LARAMIE COUNTY PLANNING & DEVELOPMENT DEPARTMENT

TITLE: PUBLIC HEARING regarding a Subdivision Permit & Plat for Pee-Wee Ponderosa Subdivision, Located in a Portion of the NW¹/₄ of Section 29, Township 15 North, Range 63 West of the 6th P.M., Laramie County, WY.

PZ-24-00106
 Pee-Wee Ponderosa Subdivision
 Subdivision Permit & Plat

PEE-WEE PONDEROSA

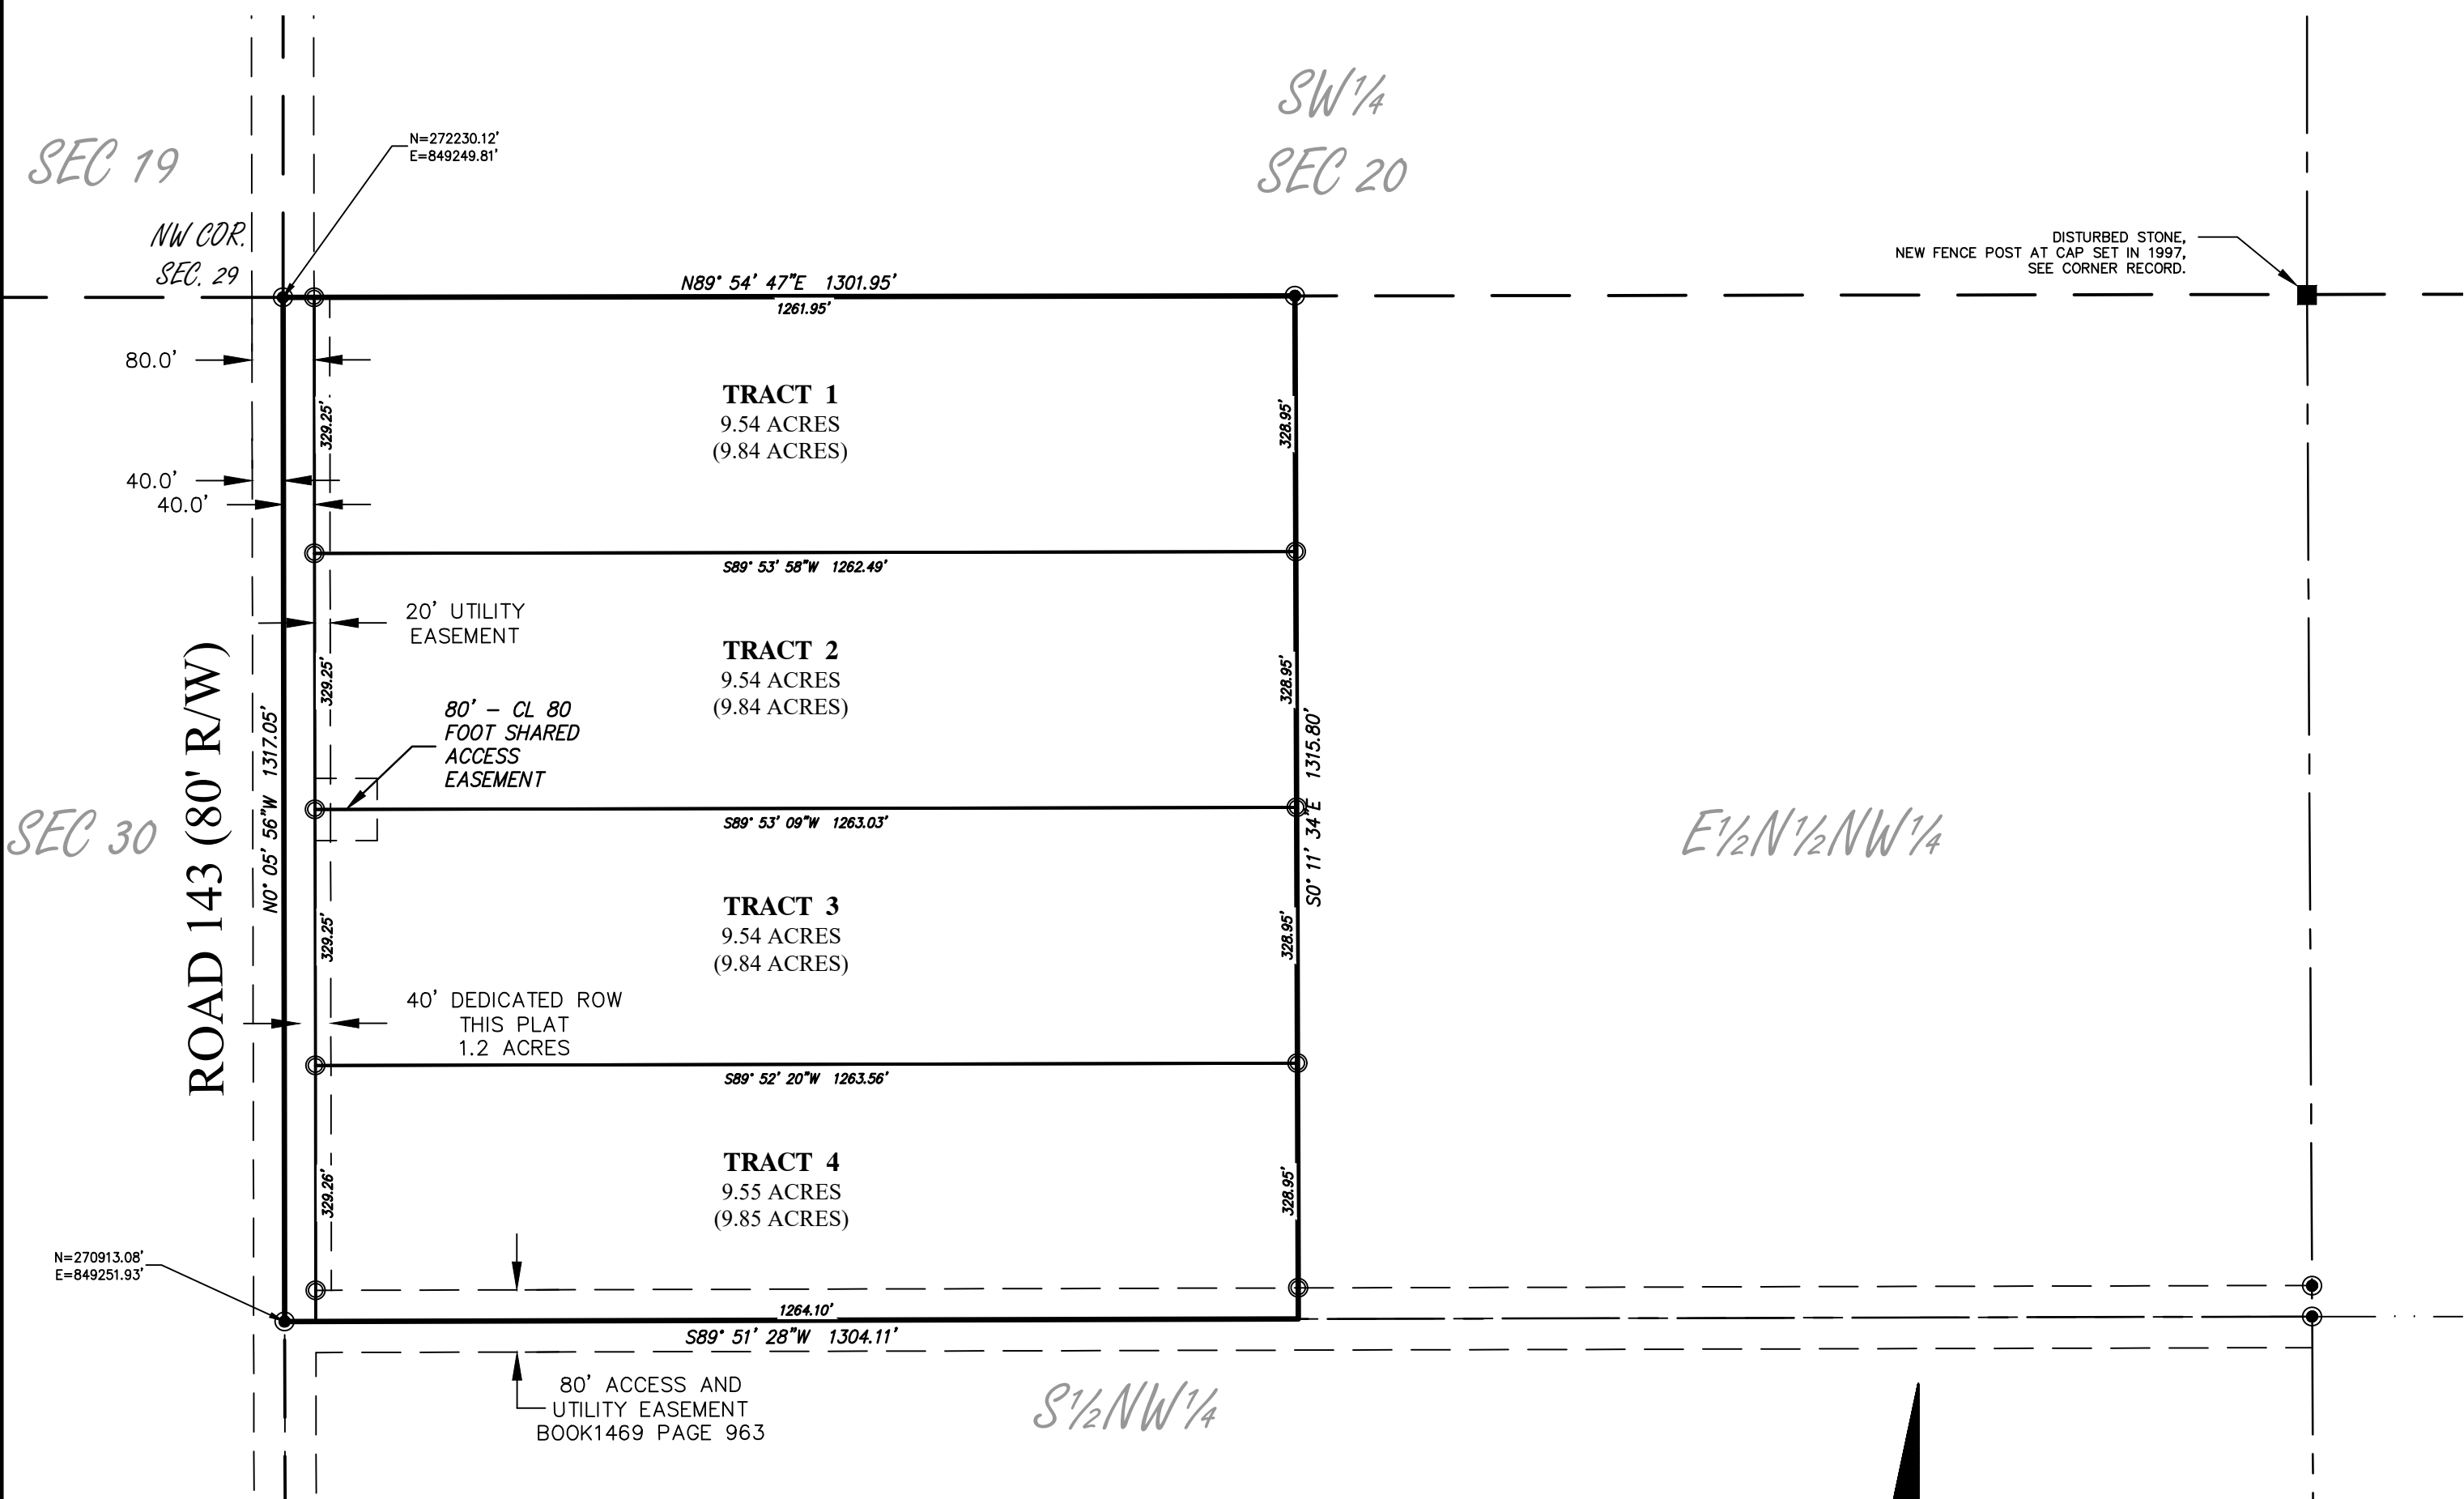
<u>Begin Date</u>	<u>End Date</u>	<u>Permit Area</u>	<u>Subject</u>	<u>Note Type</u>	<u>Note Text</u>	<u>Created By</u>
12/03/2024		Application	PZ-24-00106	GENERAL	LCPC 1/23/25, BOCC 2/18/25	BRYCE.HAMILTON@LARAMIECOUNTY.WY.GOV
12/04/2024		Application	PZ-24-00106	GENERAL	WAPA has no conflict with this project.	ROGERS@LARAMIECOUNTY.WY.GOV
12/04/2024 corrected	12/17/2024	Workflow	COUNTY ASSESSOR REVIEW	DEFICIENCY	Dedication should read: Mary Lee Sutherland (sole owner per BK 2869 PG 1046, RECP #870116). Parcel boundary data appear to be in order. No further comments on plat drawing.	CINDY.KEMIVES@LARAMIECOUNTY.WY.GOV
12/04/2024 corrected	12/17/2024	Workflow	COUNTY REAL ESTATE OFFICE REVIEW	DEFICIENCY	Ronald G Sutherland passed away on January 12, 2024. Mary recorded an affidavit on 02/26/24 book 2869 page 1046 putting the land in just her name so please remove Ronald's name from the dedication, signature and notary. Mary recorded a Transfer on Death Deed in book 2869 page 1046 in February. I believe she will need to revoke this deed after the plat is recorded as the legal on the TODD will no longer be valid.	LAURA.PATE@LARAMIECOUNTY.WY.GOV

12/11/2024		Application	PZ-24-00106	GENERAL	No comments	MATTHEW.BUTLER@LARAMIECOUNTY.WY.GOV
12/11/2024		Workflow	PLAN REVIEW BY BUILDING	GENERAL	Premises identification shall be in accordance with 2021 IFC section 505 and 2021 IRC section 319, and 2021 IBC section 502.1. Building permits shall be required for all new building construction. Laramie County has adopted the 2021 I-codes and the 2023 NEC.	DANIEL.PETERS@LARAMIECOUNTY.WY.GOV
12/17/2024	12/17/2024	Application	PZ-24-00106	GENERAL	Engineer Review 1.I agree that a Drainage Study and Traffic Study is not warranted for this plat application. 2.Per the LCLUR Section 3-5-107 c.iii.B, accesses need to be spaced at a minimum of 550 along Road 143. The individual Tracts are only approximately 329 which does not meet the minimum requirement. Therefore, the Tracts will not be able to access directly to Road 143 and will need to access 143 via the 80 access and utility easement. An access roadway with an easement (or dedicated) within Tracts 2, 3, and 4	SCOTT.LARSON@LARAMIECOUNTY.WY.GOV

should be created to allow the Tracts to go south, tie into the existing 80 access easement and then access Road 143.
 3.Any and all access utilized to gain access to this subdivision (i.e., like using the existing 80 access easement) shall be paved to the ROW line of Road 143 at a minimum.
 4. Just an FYI, the year shown for all approvals and acknowledgements on the plat drawing may need to be changed to 2025 if all signatures are not obtained prior to December 31, 2024.

Surveyor Review
 1. Is the 80 ACCESS AND UTILITY EASEMENT along the south boundary of TRACT 4 (BOOK 1469 PAGE 963) dedicated to the public?
 2. Is ROAD 143 an official Laramie County Road created according to statutory requirements? If so, including the PETITION NUMBER for the road on the plat would clarify its status.

12/18/2024	Application	PZ-24-00106	GENERAL	<p>1) If Ronald Sutherland is deceased, we will need some proof that he is deceased for the record. This shouldn't require a new deed. 2) The dedication will need only her name on it.</p>	LARAMIECOUNTY ATTORNEY@LARAMIECOUNTY.WY.GOV
12/18/2024	Workflow	PLAN REVIEW BY ENVIRONMENTAL HEALTH	GENERAL	<p>Each lot requires a small wastewater permit. Septic systems must be kept 50 ft from property lines and 50 ft from drainage. Easements are less than property setback requirements so should not cause issues. Signed final plat must be submitted to Environmental Health prior to application for permits.</p>	TIFFANY.GAERTNER@LARAMIECOUNTY.WY.GOV
12/19/2024	Workflow	PUBLIC WORKS REVIEW	GENERAL	<p>1. All comments from the review engineer and surveyor shall be addressed. 2. It appears the access easement on the south side of this subdivision is within the boundaries of this plat. Should it be? 3. Access for these lots needs to be confirmed as requested by the review engineer. Any publicly dedicated access easements (outside of Road 143) shall be built to the Laramie County Land Use Regulations. 4. Public Works had a resident within close proximity stop by our office to provide feedback and express her concerns. I do not see that in the record yet, but we did encourage her to send an email and make a formal comment. 4a. Her concerns were related to drainage. Looking at the aerial picture I can see where there could be a concern on how the water will flow through the properties. There is no designated flood zone, however, I could see value in getting information for the culvert under 143 adjacent to these tracts. 5. Future infrastructure upgrades may be required with this development. This could include but is not limited to access, right-of-way (road construction), re-vegetation and signage. Permit applications through Public Works will be required at the time of development.</p>	MOLLY.BENNETT@LARAMIECOUNTY.WY.GOV

01/16/2025		Application	PZ-24-00106	GENERAL	2nd review Prior comments were addressed, and other agency's noted the location of the recorded affidavit putting the land in her name. No further comments.	LARAMIECOUNTY ATTORNEY@LARA MIECOUNTYWY.G OV
01/16/2025		Application	PZ-24-00106	GENERAL	[Mark and Brad] - Suggest subrogation of easement rights prior to dedication of the road to the County. The decision to accept it should consider the neighbors down the road and notice is likely the best route and this decision should be made by the commissioners. Please pull the easement for our review.	LARAMIECOUNTY ATTORNEY@LARA MIECOUNTYWY.G OV
01/16/2025		Workflow	PUBLIC WORKS REVIEW	GENERAL	1. The 80 foot access and utility easement along the southern boundary of tract 4 shall be built to the current Laramie County Land Use Regulation road standards. 2. The proposed shared access easement between Tract 3 and 4 does not meet the Laramie County Land Use Regulation spacing and will not be granted as proposed.	MOLLY.BENNETT @LARAMIECOUNT YWY.GOV

01/23/2025		Application	PZ-24-00106	GENERAL	3rd round reviews assigned to Engineer, Public Works. Responses and revision in submittals. Molly, did you want to request dedication of the section line on this plat? Not sure if that was intentional or overlooked.	BRYCE.HAMILTON @LARAMIECOUNT YWY.GOV
01/23/2025	01/23/2025	Application	PZ-24-00106	GENERAL	3rd Review - The Access Note on the revised plat along with the shared access easement adequately addresses my previous comment. No further comments at this time.	SCOTT.LARSON@ LARAMIECOUNTY WY.GOV
02/04/2025		Workflow	PUBLIC WORKS REVIEW	GENERAL	1. The entirety of the access along the southern boundary of this plat shall be designed and constructed to meet the Laramie County Land Use Regulations. Permit applications through Public Works will be required. Call (307-633-4302) or email (permits@laramiecountywy.gov) Public Works for more information.	MOLLY.BENNETT @LARAMIECOUNT YWY.GOV

02/10/2025	02/10/2025	Application	PZ-24-00106	GENERAL	4th Review - Each lot/tract shall have an engineer perform an analysis to determine the correct size and type of culvert that will be needed for each access road. The engineer shall submit their analysis to the County with the access permit for review and approval. There is a natural drainage that crosses all lots (north to south) that will need to be accounted for when designing/developing the access roads.	SCOTT.LARSON@ LARAMIECOUNTY WY.GOV

- 1. ack
- 2. the lots will access 143 using shared access. that way they meet the lclur.

- 3. ack
- 4. changed

- 1. it doesn't appear to be
- 2. question for laramie county.

- 1. ack
- 2. corrected

- 1. ack
- 2. yes
- 3. see response to engineer
- 4. ack
- 5. ack

- TRACT 4 WILL BE ACCESSED FROM THE 80' ACCESS EASEMENT ALONG THE SOUTH SUBDIVISION LINE.
- TRACT 3 AND 2, WILL BE ACCESSED VIA SHARED ACCESS EASEMENT AS SHOWN.
- TRACT 1 WILL BE ACCESSED ALONG THE NORTH SUBDIVISION LINE TO MAINTAIN SIGHT DISTANCE.
